JERSEY CENTRAL POWER & LIGHT COMPANY
OYSTER CREEK NUCLEAR GENERATING STATION

Technical Specification
Change Request No. 98
Docket No. 50-219

Applicant submits, by this Technical Specification Change Request No. 98 to the Oyster Creek Nuclear Generating Station Technical Specifications, a change to Specifications Sections 2.2, and 2.3.

SAFETY EVALUATION FOR THE
INCREASE IN THE OYSTER CREEK
RELIEF VALVE SET POINTS

FIGURE 3a

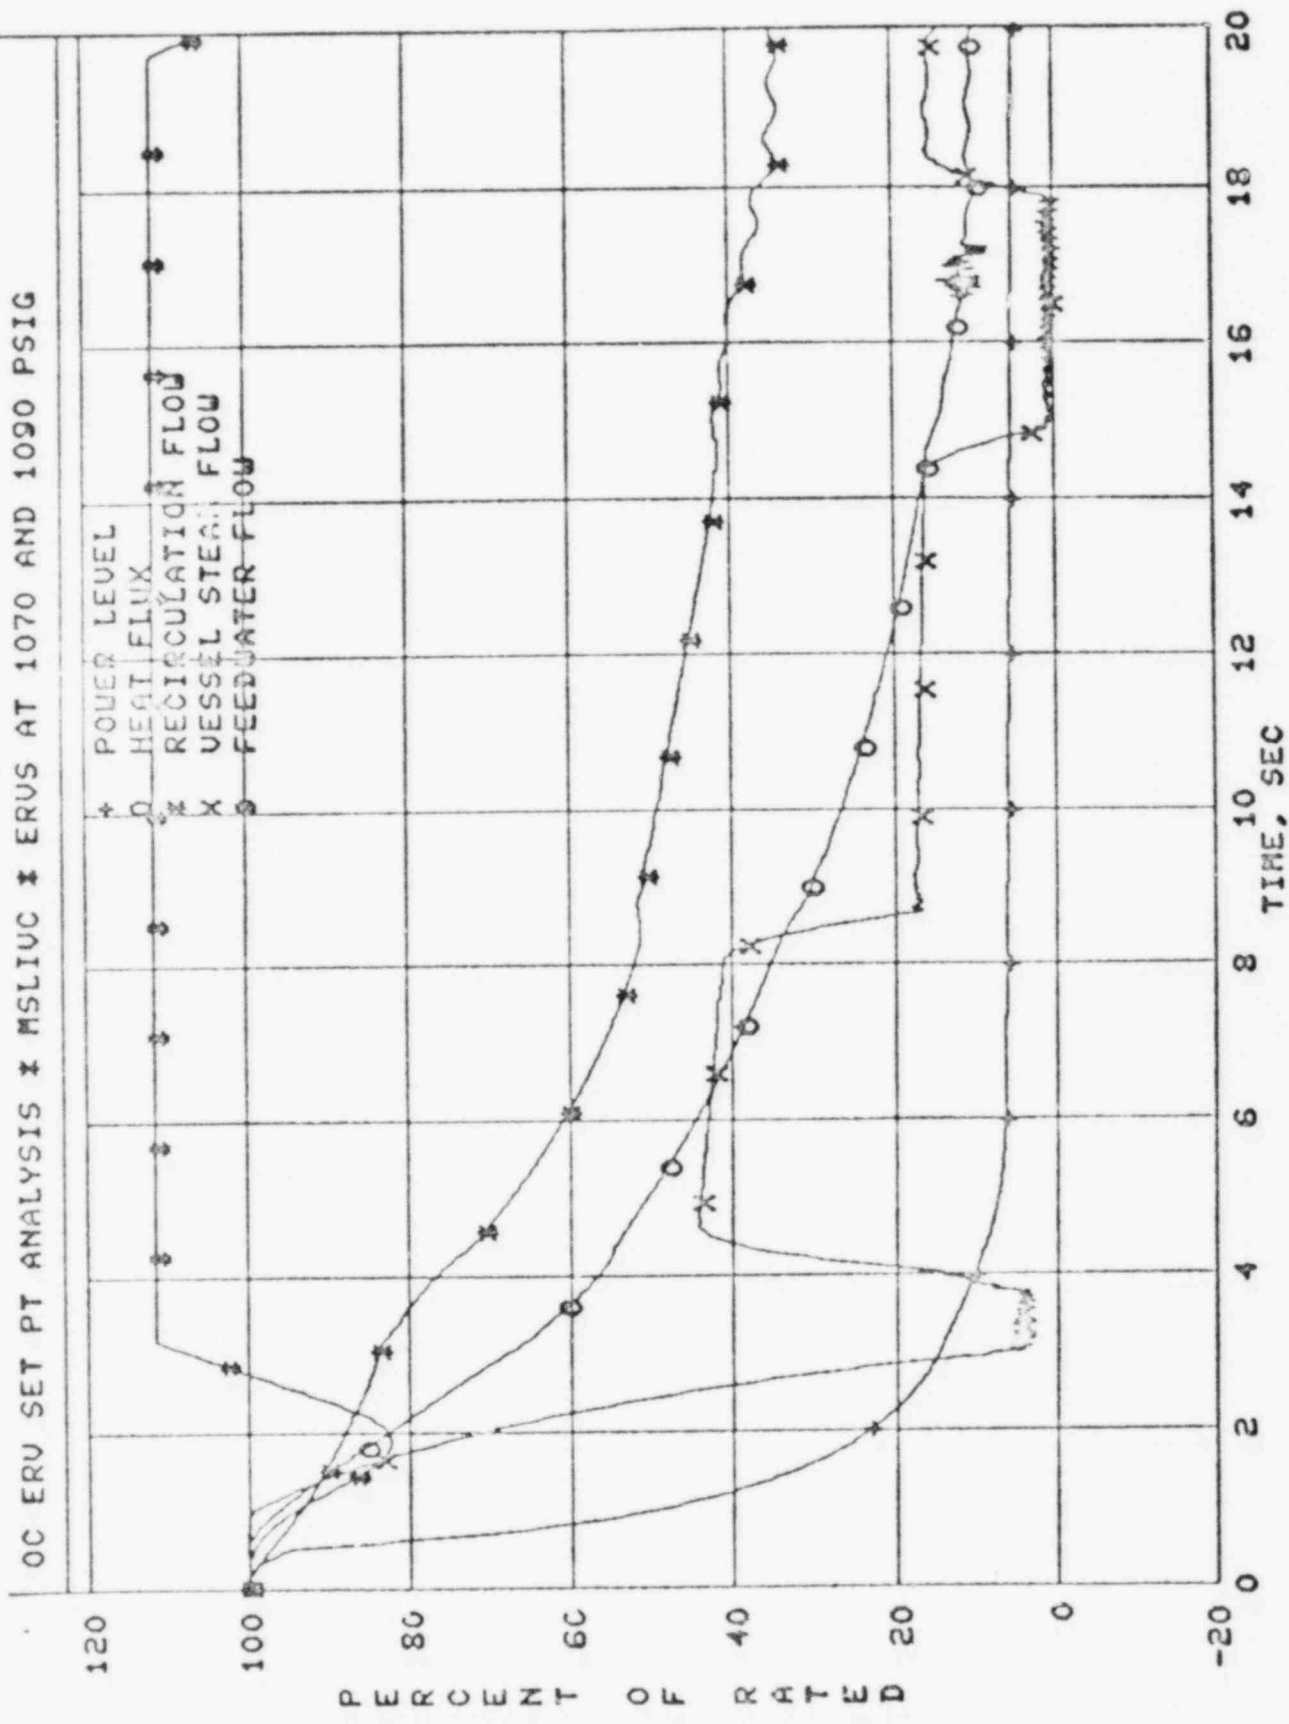
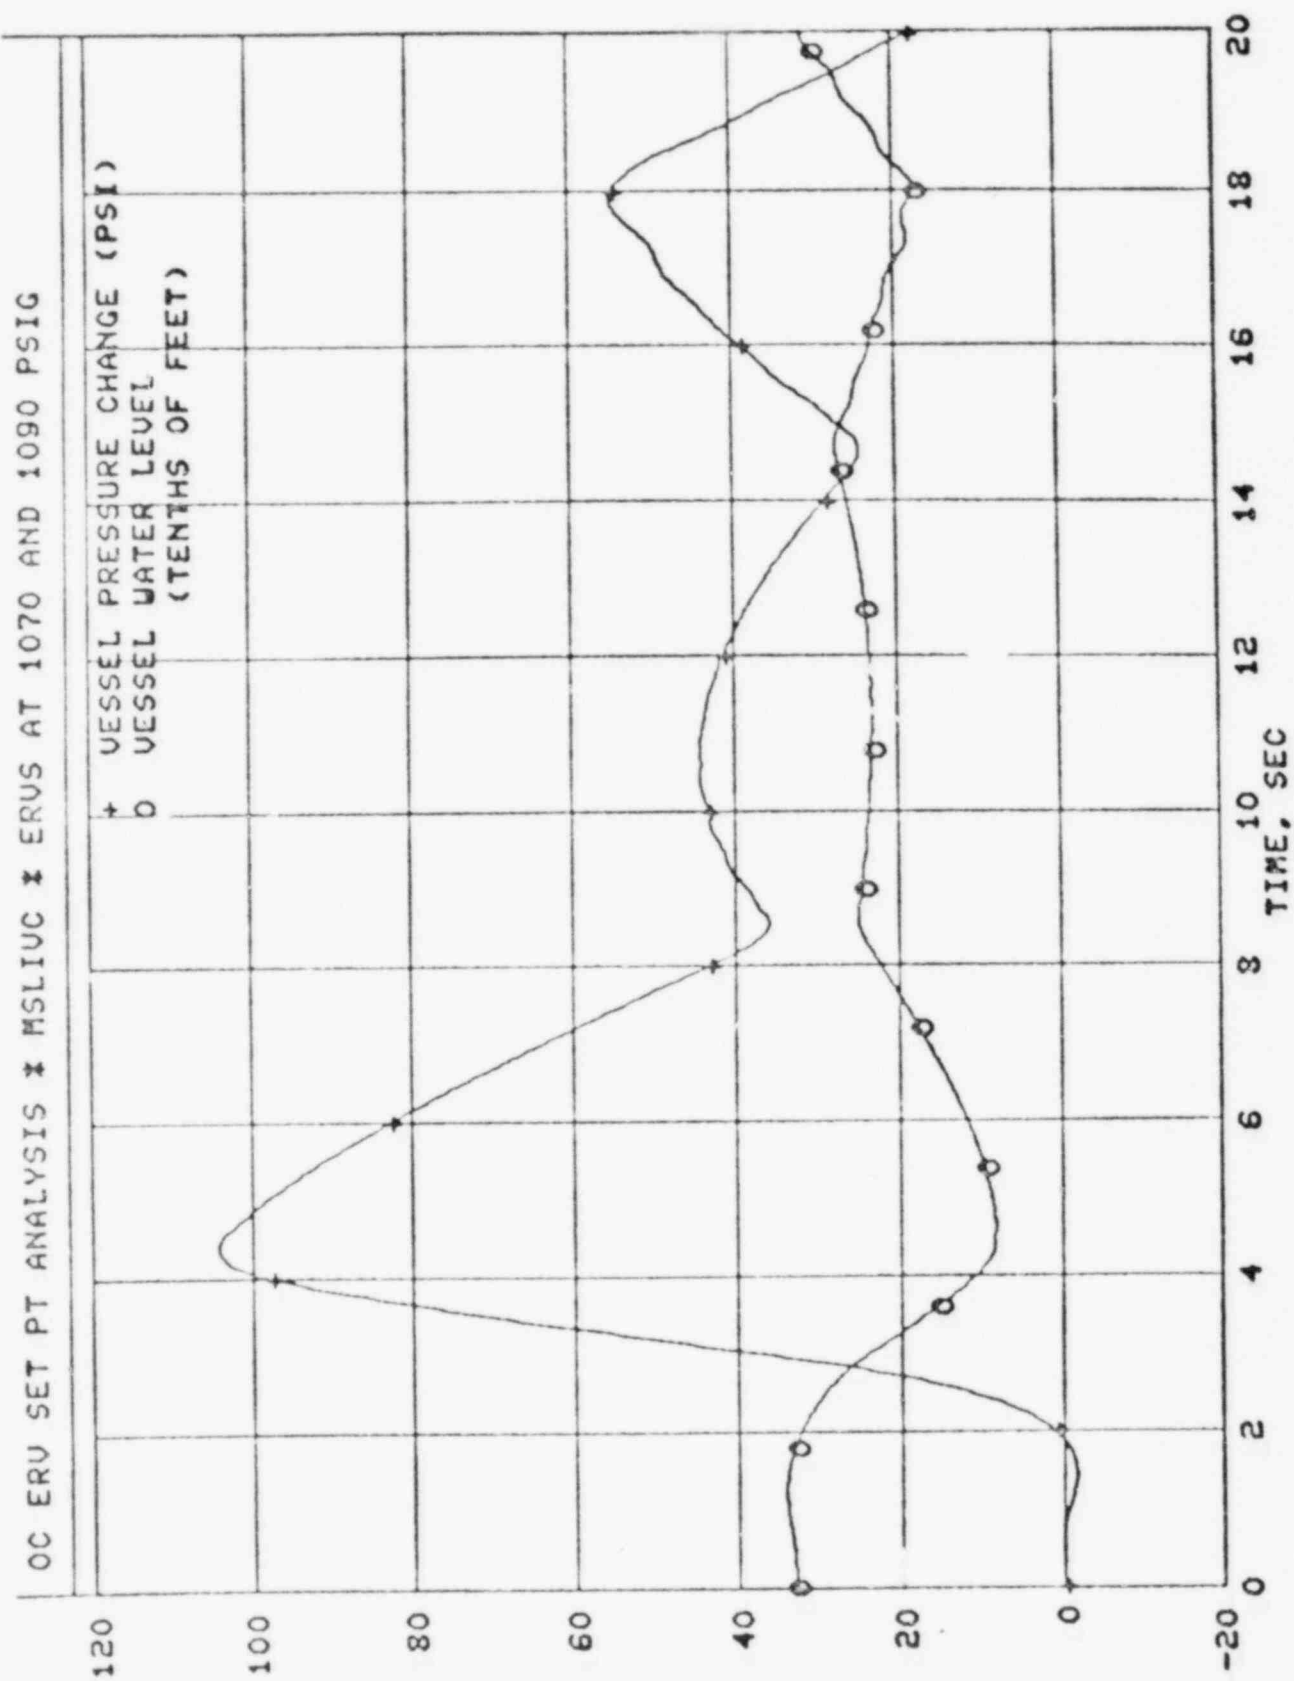
The transient resulting from a 3 second closure of the main steam line isolation valves is shown in Figures 3a and 3b. Two relief valves open at 3.7 seconds and all five are open by 4.0 seconds, remaining open to 14.9 seconds. A peak pressure of 1135.4 psia occurs at 4.5 seconds which is well below SV set points. The analysis shows that the relief valves would reopen at 18 seconds. Operation of the isolation condenser, for which no credit is taken in this analysis, would prevent subsequent lifts.
